URGENT Field Safety Notice: RA2020- 2329946

URGENT MEDICAL DEVICE SAFETY NOTICE & CORRECTION

Infant Child Reduced Energy Electrodes for Physio-Control LIFEPAK® Defibrillators

Affected area of pouch unsealed

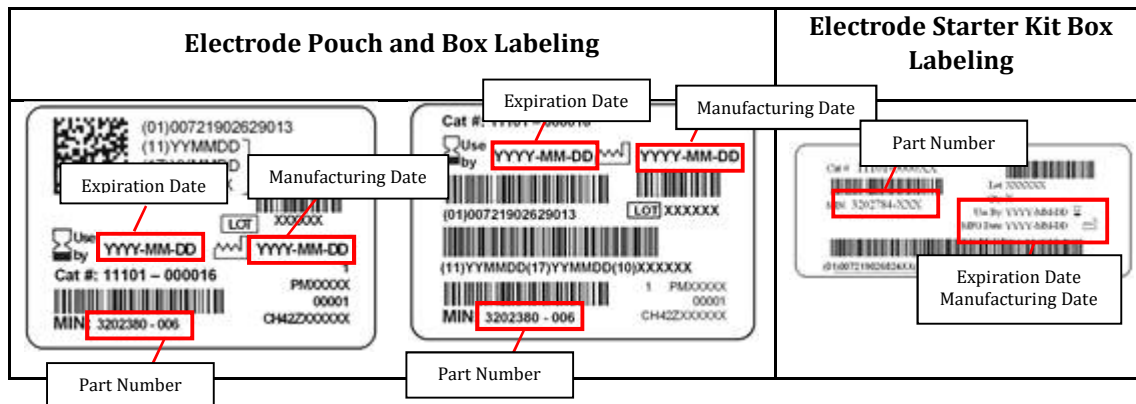
Stryker has become aware that certain packages of Infant Child Reduced Energy Electrodes produced by Cardinal Health, Inc. may have compromised packaging seals. The compromised packaging seal has the potential to result in the electrodes becoming dried out. This could result in inadequate adhesion to patient, failure of the defibrillator to detect patient connection, ineffective or no energy delivered to patient, or patient burns. Stryker estimates that only 1% to 2% of potentially affected product may exhibit packaging that has visible openings (compromised seals) as shown in the bottom figure. There have been no patient related events associated with this issue.

1. Inspect your own Infant Child Electrode inventory to identify any electrode packages that have a compromised packaging seal as shown in the figure below and destroy any product suspected to exhibit this condition. Note: only inventory manufactured between August 2017 and October 2019 are affected and will need to be inspected.
2. Complete the enclosed "Acknowledgement and Receipt Form" on behalf of your organization and return it as directed to confirm your receipt and understanding of this information. Upon return of this form, you will be provided the replacement electrodes. If you do not have any impacted product, it is still required that you complete and return the form with the box checked indicating "No inventory."
